UNITED STATES PATENT AND TRADEMARK OFFICE

APPLICATION NO.	FILING DATE	FIRST NAMED INVENTOR	ATTORNEY DOCKET NO.	CONFIRMATION NO.
10/731,186	12/09/2003	Tetsuji Ueda	52201-0611	4872
28481	7590	03/25/2005	EXAMINER	
TIAJOLOFF & KELLY			HERRING, LISA L	
CHRYSLER BUILDING, 37TH FLOOR			ART UNIT	
405 LEXINGTON AVENUE			PAPER NUMBER	
NEW YORK, NY 10174			1731

Office Action Summary

DETAILED ACTION

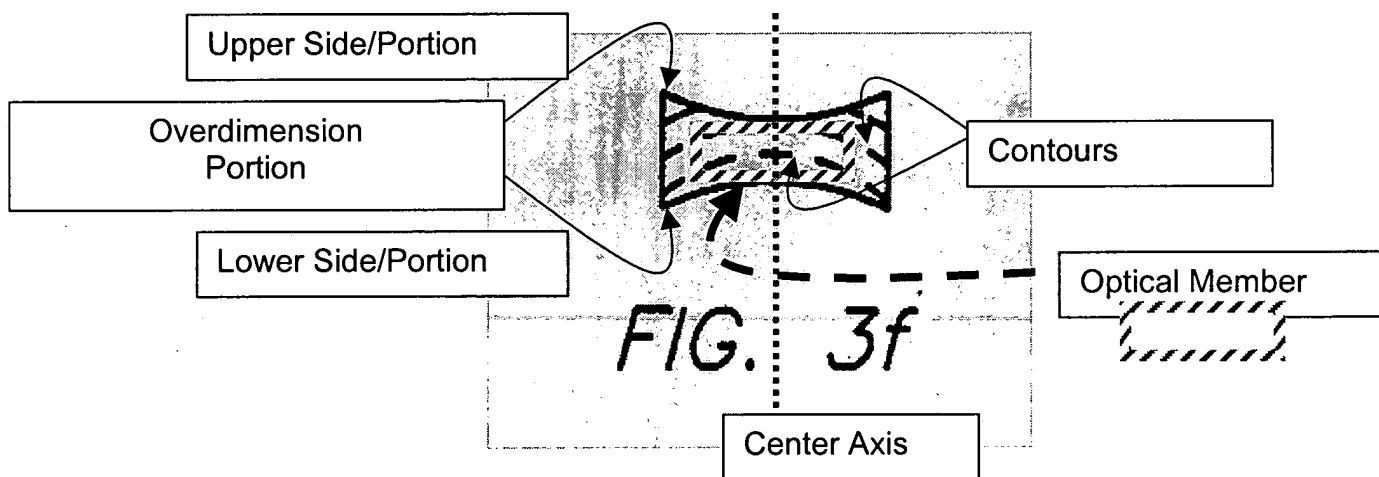
a) providing a blank (Figs. 3d, 3e, and 3f), which includes a contour portion that can be used for the contour of the optical member to be produced (Col. 6, line 65 to Col. 7, line 15) and an overdimension portion (Fig. 2c and Col.6, line 65 to Col. 7, line 15) that has a surface which is defined by a lower side, an upper side opposite said lower side and spaced apart therefrom, and an outer edge extending around a center axis, (claim 46)

d) using a preform wherein the overdimension portion includes a thickened portion which extends from the outer edge towards the center axis, the thickened portion varying in thickness so that the distance between the lower side and the upper side in an area adjacent the outer edge is greater than the distance between the lower side and the upper side in an area of the center axis (claim 48) (See Fig below and Col. 6, line 65 to Col. 7, line 8)

Blankenbecler fails to specifically disclose the measures provided which, during cooling, keep conduction in an area adjacent said outer edge lower than in an area adjacent said center axis and the measures comprise use of a preform as the blank wherein said overdimension portion includes a thickened portion which extends from

said outer edge towards said center axis; said thickened portion varying in thickness so that the distance between the lower side and the upper side in an area adjacent the outer edge is greater than the distance between the lower side and the upper side in an area of the center axis. However, since the blank disclosed by Blankenbecler (See Figure above) includes all of these limitations, it is inherent in the process of annealing and cooling the blank 3f in Blankenbecler, that measures are provided, during cooling, keep conduction in an area adjacent said outer edge lower than in an area adjacent said center axis (claim 46) or alternatively, heat conduction from the contour portion adjacent said outer edges is limited more than adjacent said center axis. If applicant interprets this is not inherent in the process of Blankenbecler when applied to blank 3f, it would have been obvious to one skilled in the art at the time the invention was made that the additional mass at the edges of blank 3d, 3e, or 3f will keep conduction in an area adjacent said outer edge lower than in an area adjacent said center axis (claim 46) or alternatively, heat conduction from the contour portion adjacent said outer edges is more limited than adjacent said center axis.
